**EL DORADO COUNTY DEVELOPMENT SERVICES
PLANNING COMMISSION
STAFF REPORT**

Agenda of: January 8, 2009
Item No.: 8.a
Staff: Jason R. Hade

FILE NUMBERS: S07-0020/Pacific House Auto Repair

REQUEST: Special use permit (SUP) to authorize an automotive service and repair facility, one single wide trailer, two duplexes (each with two units), six storage buildings, four cargo containers, café/bar, and a 12-foot tall sign with 32 square feet of display area advertising automotive service and repair facility.

EXHIBIT E

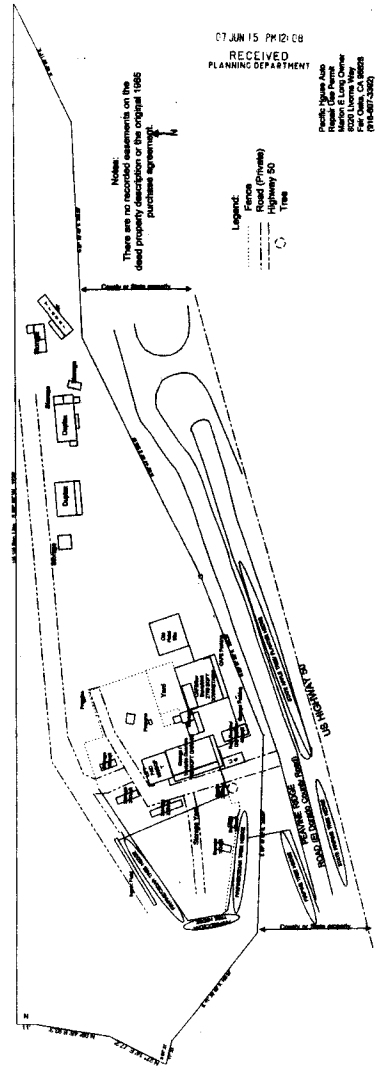
No additional exterior project lighting is proposed. However, staff has determined that the existing lighting shown on the site plan (Exhibit E) and in the site inspection photos (Exhibit F) is not in compliance with the County’s Outdoor Lighting Ordinance. As such, within 60 days from the date of SUP approval, all outdoor lighting fixtures would need to be modified or replaced to meet the requirements of the Outdoor Lighting Ordinance.

The subject site is located within the Sierra Design review district as well as a designated State Scenic Highway corridor. Accordingly, the two lift pads shown on the site plan would need to be fully enclosed within a building or removed. All storage yards, water storage tanks, and automotive equipment would need to be fully screened with fencing (wooden or chain link with brown slats) within 60 days of S07-0020 approval, if approved. The former dilapidated service station would need to be removed as well.

4. Within 60 days from the date of SUP approval, an additional 21 parking spaces shall be developed in compliance with Exhibit E. A total of 29 off-street parking spaces shall be provided at all times while the automotive service and repair facility is in operation pursuant to 17.18.060 of the Zoning Ordinance. All on-site parking shall meet the parking lot design standards contained in Chapter 17.18 of the County Code.

7. Within 60 days from the date of SUP approval, all outdoor lighting shall conform to Section 17.14.170 of the County Code and be fully shielded pursuant to the Illumination Engineering Society of North America (IESNA) full cut-off designation, as determined by Planning Services.

8. Within 60 days from the date of SUP approval, the two lift pads shown on the site plan shall be fully enclosed within a building or removed. Construction of an additional structure to enclose the lift pads will require the submittal of a special use permit revision application. All storage yards, water storage tanks, and automotive equipment shall be fully screened with

EXHIBIT F

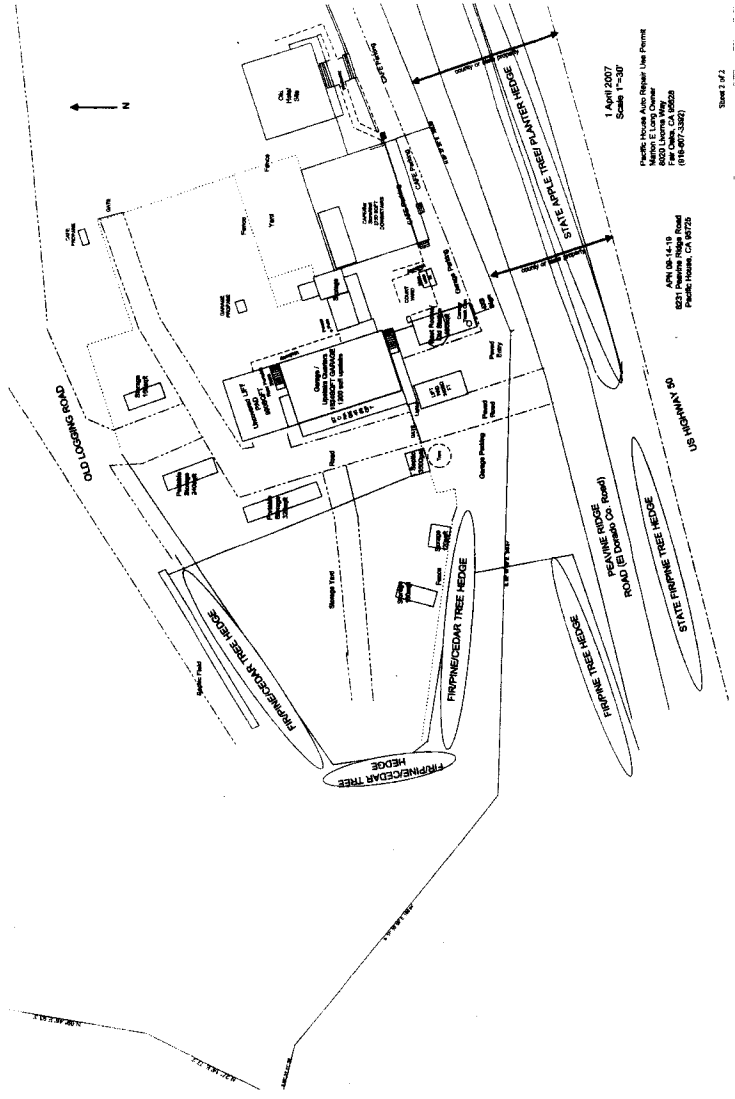
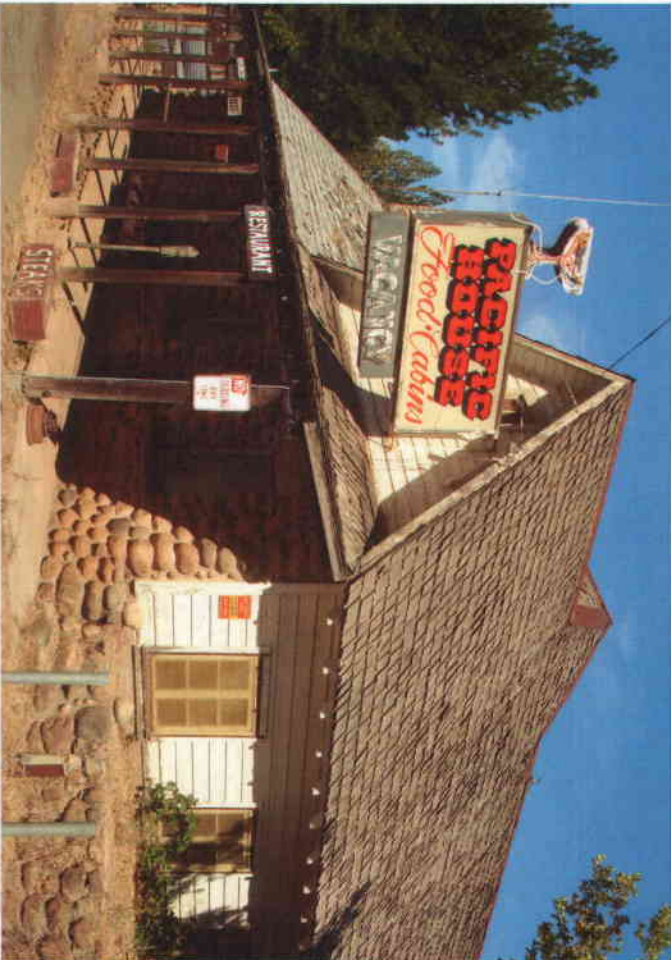
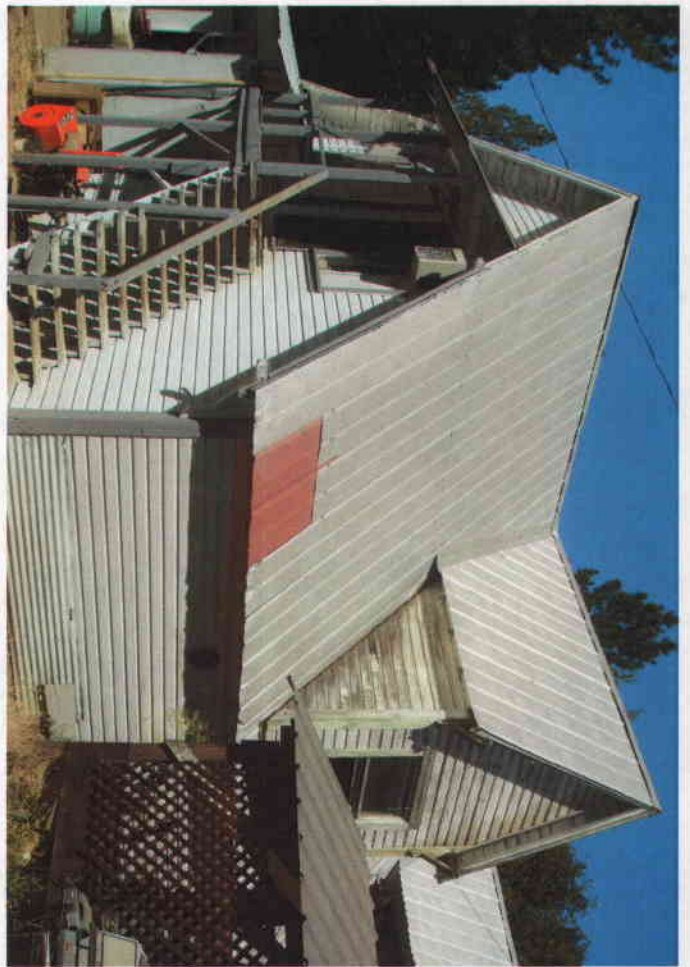
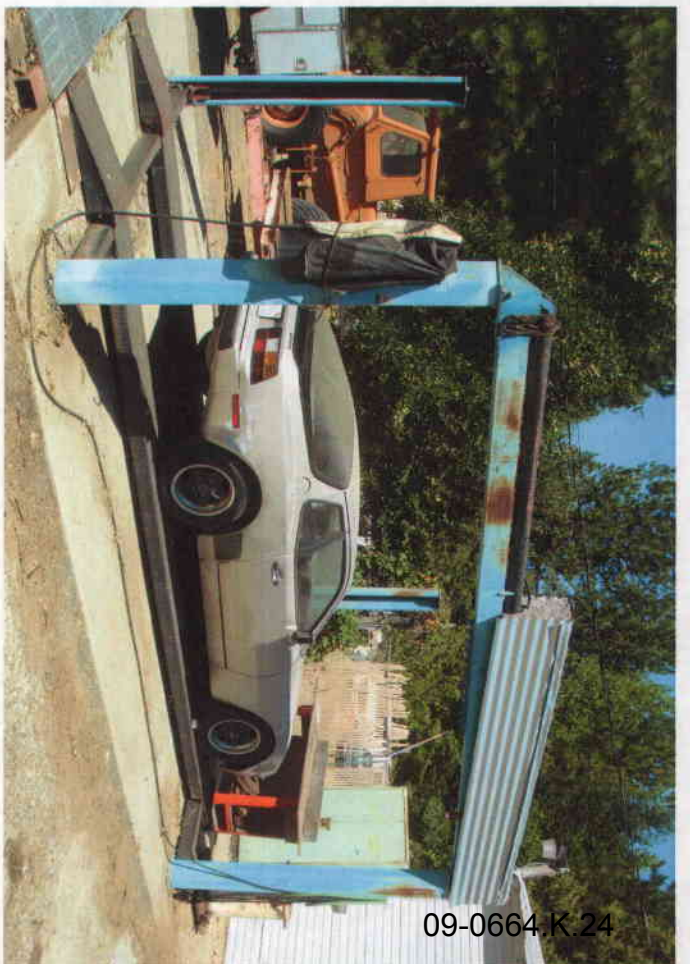
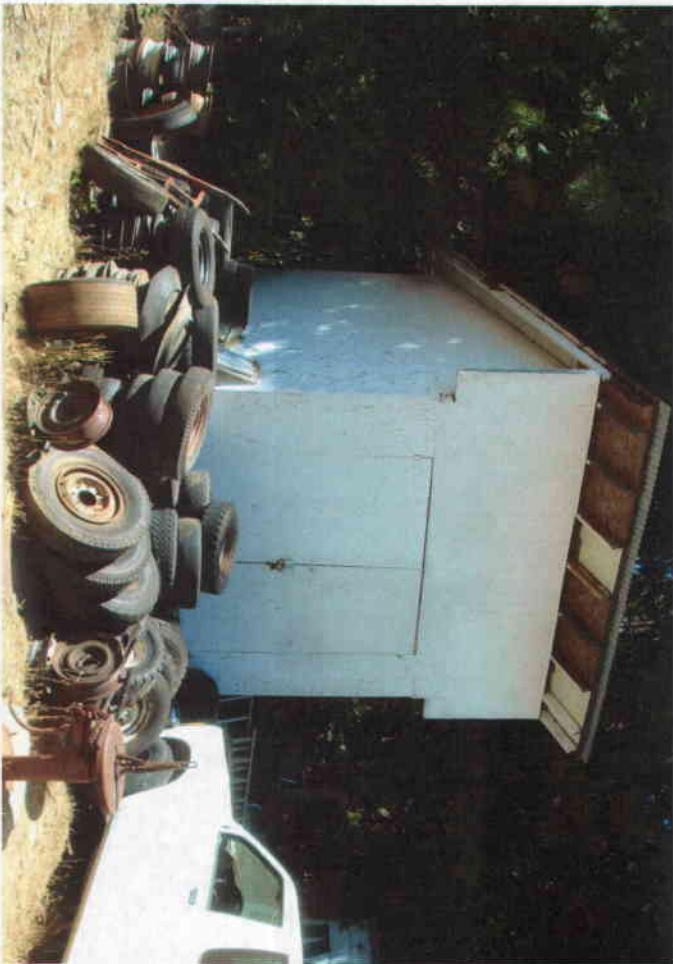
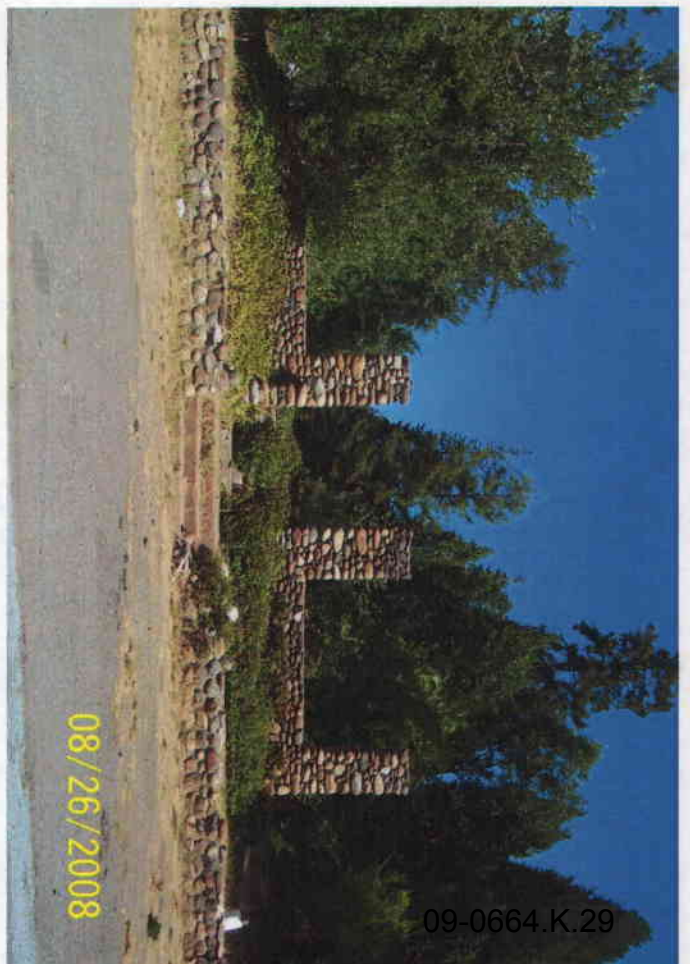
In addition to the existing Pacific House sign on the café/bar, the applicant has proposed a 12-foot tall sign with 32 square feet of display area advertising automotive service and repair facility shown in the site inspection photos (Exhibit F). Staff found the requested signage to be consistent with the signs permitted by right within the Commercial zone district. However, the Pollock Pines Design Review Committee reviewed the project on September 11, 2008 and had concerns about the proposed signage. Within 60 days from the date of S07-0020 approval, if approved, the Pollock Pines Design Review Committee would need to review and comment on the finalized sign design pursuant to their comments of September 11, 2008 (Exhibit H).

10. The Pollock Pines Design Review Committee shall review and comment on the finalized sign design within 60 days from the date of SUP approval.
11. Within 60 days from the date of SUP approval, the applicant shall pay all Development Services fees.
